DART SERVICE BULLETIN

Dart Service Bulletin Number: DSB-D212-725-1

Purpose: To update existing Eagle Single aircraft for compliance to latest certification requirements following FAA review

FIGURE 1: D212-725-6-007 VNE PLACARD

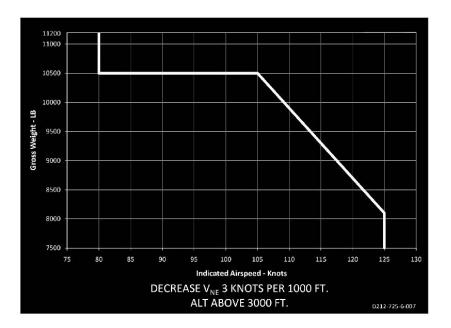
1) The D212-725-6-007 Rev. E VNE Placard (shown in Figure 1 below) must be installed over the existing VNE placard on the aircraft instrument panel.

FIGURE 2: D212-725-6-009 FUEL QUANTITY PLACARD

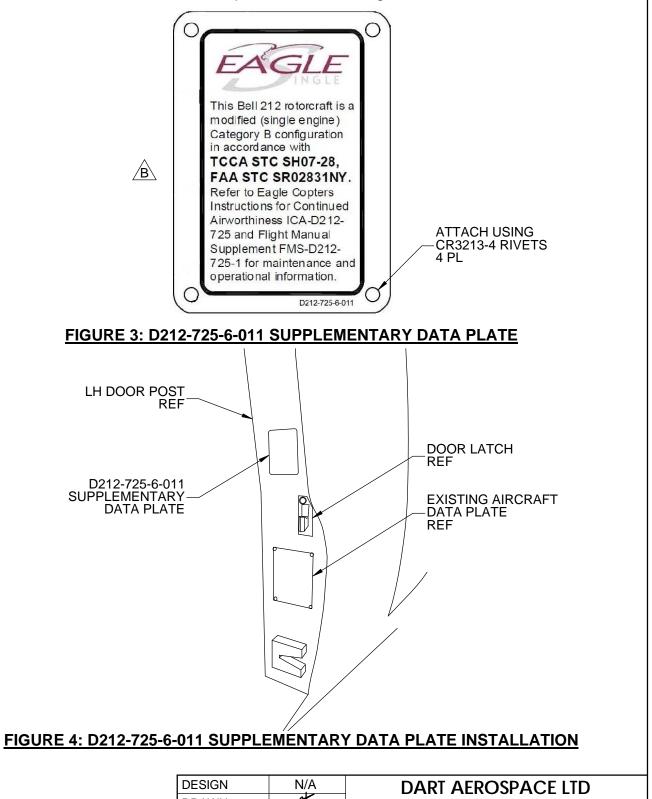
The D212-725-6-009 Rev. E Fuel Quantity Placard (shown in Figure 2 below) must be installed on the instrument panel if the existing fuel quantity placard is covered by the new D212-725-6-007 Placard.

FIGURE 5: 5A58.22.18K.22.1HN AIRSPEED INDICATOR

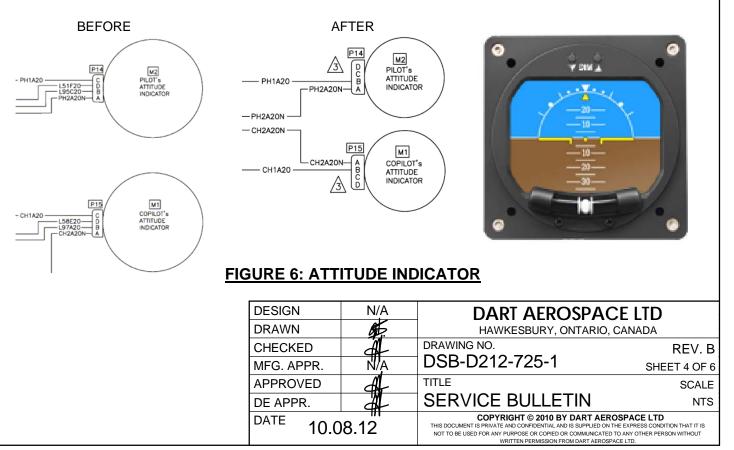
- 4) Remove existing engine mounts and replace with Dart D205-770-011 Replacement Engine Mount Kit per IIN-D205-770 (provided with replacement engine mount kit). The D205-770-011 Replacement Engine Mount Kit is already installed on aircraft s/n 30866.
- 5) Remove existing p/n 5A58.22.18K.22.1EN airspeed indicators (redlined at 130 kias) and replace with p/n 5A58.22.18K.22.1HN airspeed indicators (redlined at 125 kias) (shown in Figure 5 below).
